Substantive response of the Local Highway Authority to a planning consultation received under The Development Management Order.

Planning Application Number: 25/00983/NMA

Application Address: Land South Of Sketchley Grange Hotel Sketchley Lane Burbage Leicestershire

Description of Application: Re-consultation. Non material amendment to planning permission 23/01204/REM. Amendment to widen the public right of way, create a new footpath and relocate the play area and subsequent amendments to condition 5 and 7

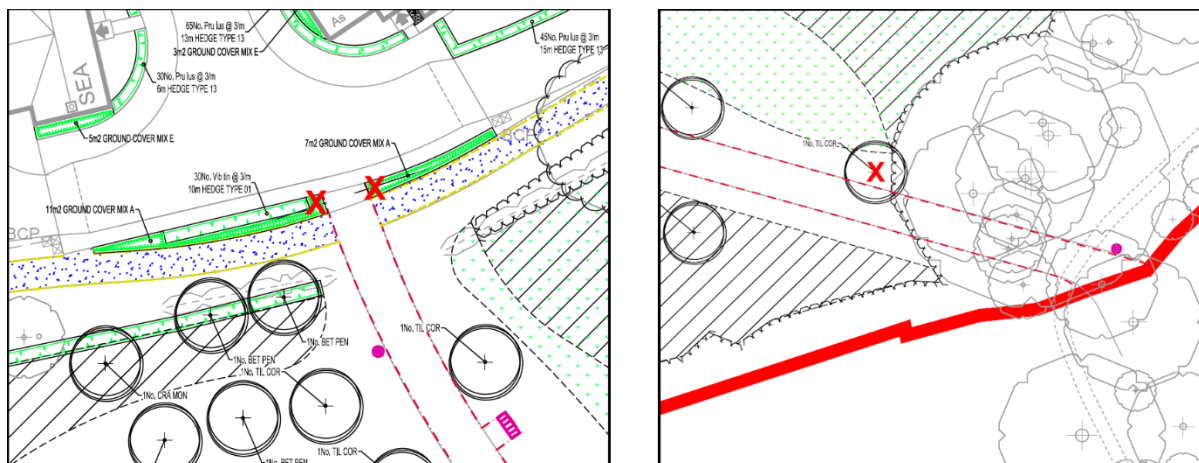
The eastern branch of U67 is remaining in its current location and the LHA will shortly add a 3.0 metre tarmac surface, funded by a previous development to the south of this site. This route will then be a cycleway for active travel between Sketchley Lane and the A5.

For historical reasons the U67 western branch has long been inaccessible. Through the northern part of this development, the bridleway will be replaced by estate roads. Through the southern part of the development, the bridleway becomes a non-motorised spine route through the public open space then feeding onto the new cycleway noted above.

Surfacing: The applicant has recently submitted 'Detailed Soft Landscape Proposals for Plots and POS' sheet 04 Revision W which confirms U67 is to have a 3.0 wide Bitumen Macadam Surface with concrete edgings. This is welcome. However, the applicant is advised that construction should match the cycleway standard on LHDG drwg. SD/1100/05 see <https://www.leicestershirehighwaydesignguide.uk/sites/lcchighwaydesign/files/2024-11/sd-1100-05-footway-vehicular-and-agricultural-field-access.pdf> If the route is constructed to adoptable standards the LHA will take on responsibility for the surface. Whereas if another standard is used then maintenance remains the responsibility of the landholder.

However, on the submitted 'Detailed Soft Landscape Proposals for Plots and POS' sheet 04 Revision W where the surfaced bridleway starts heading southwards from end of the turning head of the estate road, it shows shrub planting right up to the edge of the constructed surface, at the points marked by a red 'X' on the plan excerpt here left. Also, near the eastern exit of the site, one proposed tree is much nearer the constructed surface, at the point marked 'X' on the plan excerpt right. Both these amending to comply with the LHDG.
